工程指示 / 要求簡箋(E.I.)

工程指示編號：EI/8²⁴⁵/24

工程名稱：將軍澳日出康城 11

工程項目：幕牆 起腳 收口鋁板 地盆用 T1-T3 9/F 補 5 件

| 地盘 | 康城11期 | 制圖 | W. E. X | 2022-11-11 | 圖號 | AQ-51 | |

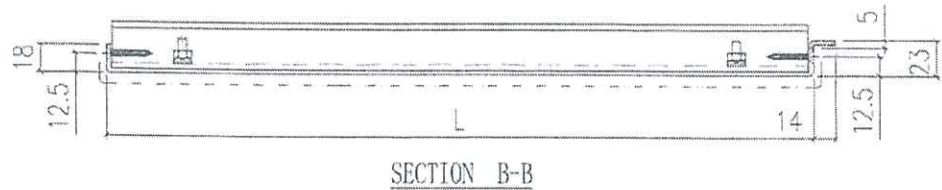
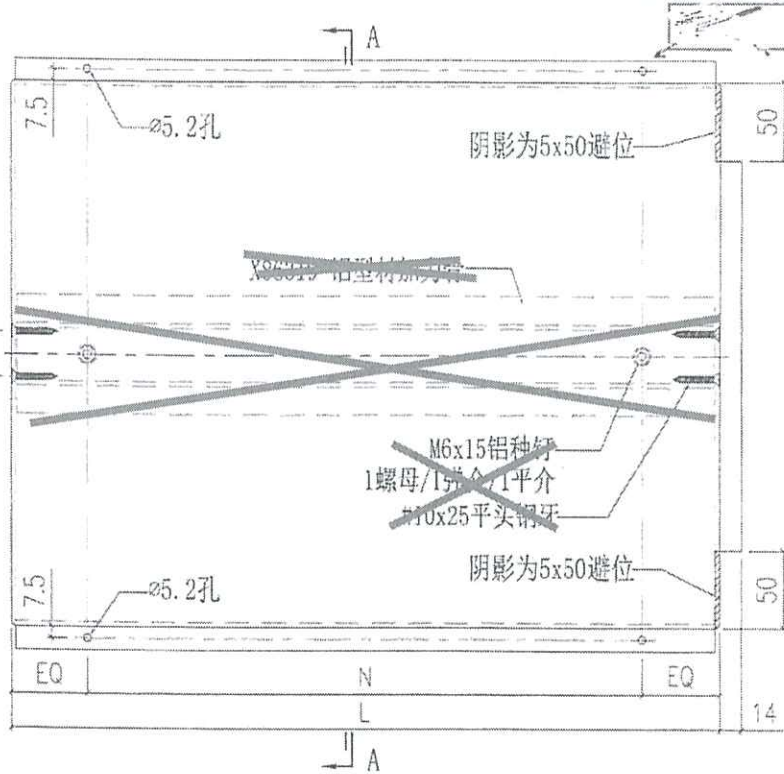
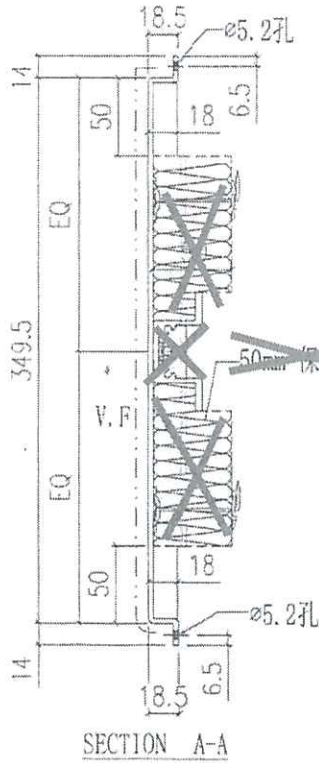
1. 因原 EI 5635 漏掉 AQ-51-22，現提供資料，補回生產 1 件

供地盤 T3 9/F ACAD 使用

T2 AGBF: AQ-51-06 要補 1 件； AQ-51-17 由現場改短

T3 AGBF: AQ-51-06 要補 1 件； AQ-51-17 由現場改短

不用加力骨，
不用棉

| 編號 | L | N |
|----------------|-------|-----------------|
| T3-AC-AQ-51-22 | 1435 | @300 c/c X 4 1件 |
| T2-BF-AQ-51-06 | 772.5 | @300 c/c X 2 1件 |
| T3-BF-AQ-51-06 | 772.5 | @300 c/c X 2 1件 |

| 日期 - | 材料顏色 PVF2 (香檳金) | 图纸名称 铝板加工图 | 復核 - | 圖號 AQ-52 |

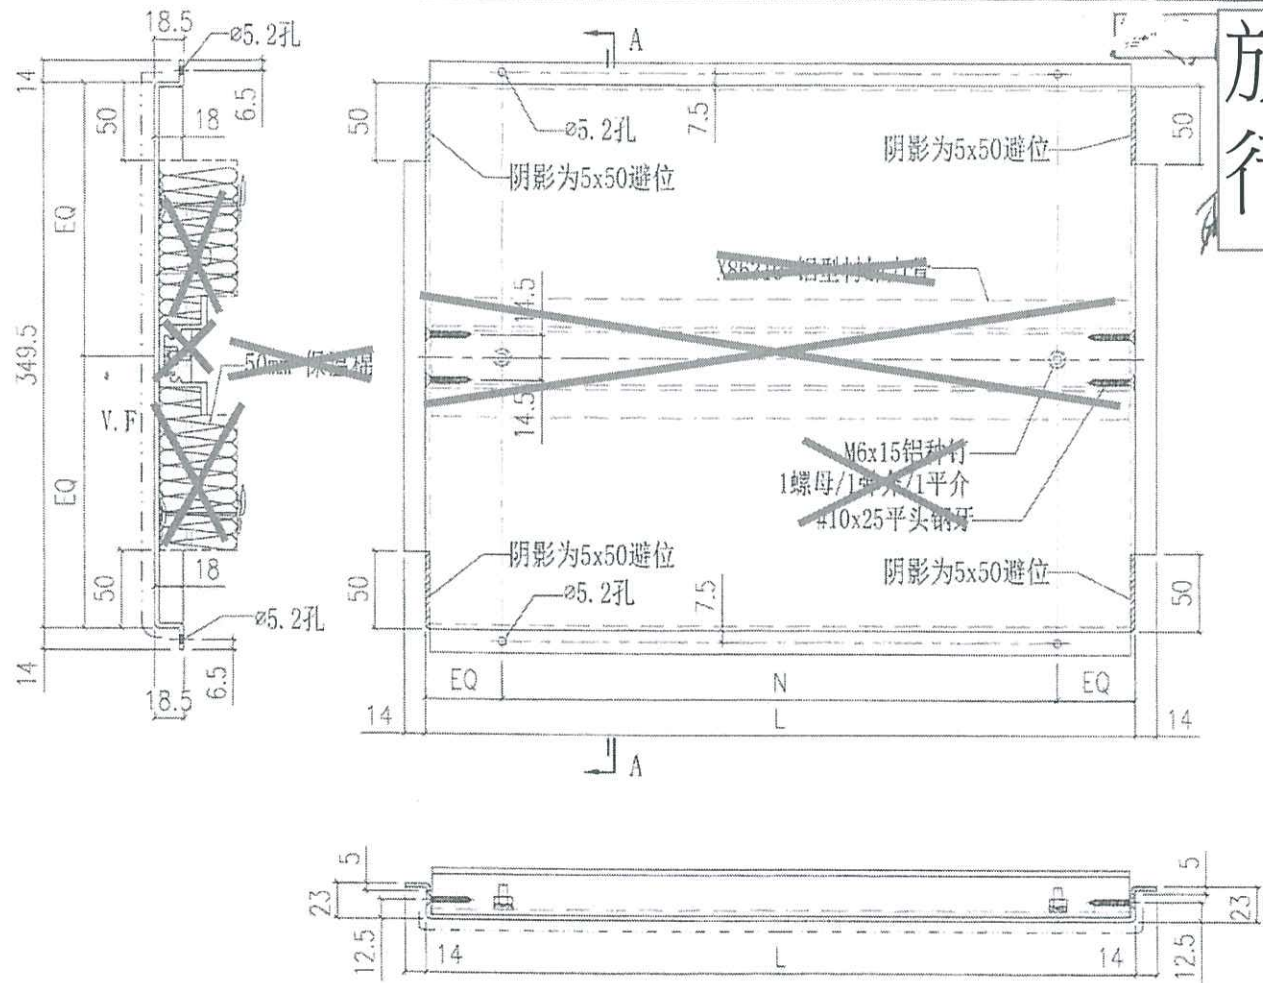
T1 AGBF: AQ-52-06 要補 1 件； AQ-51-13 由現場改短

T1 ACAD: AQ-52-06 要補 1 件； AQ-51-14 由現場改短

**不用加力骨，
不用棉**

| 編號 | L | N |
|----------------|-----|-----------------|
| T1-AC-AQ-52-06 | 735 | @300 c/c X 2 1件 |
| T1-BF-AQ-52-06 | 760 | @300 c/c X 2 1件 |
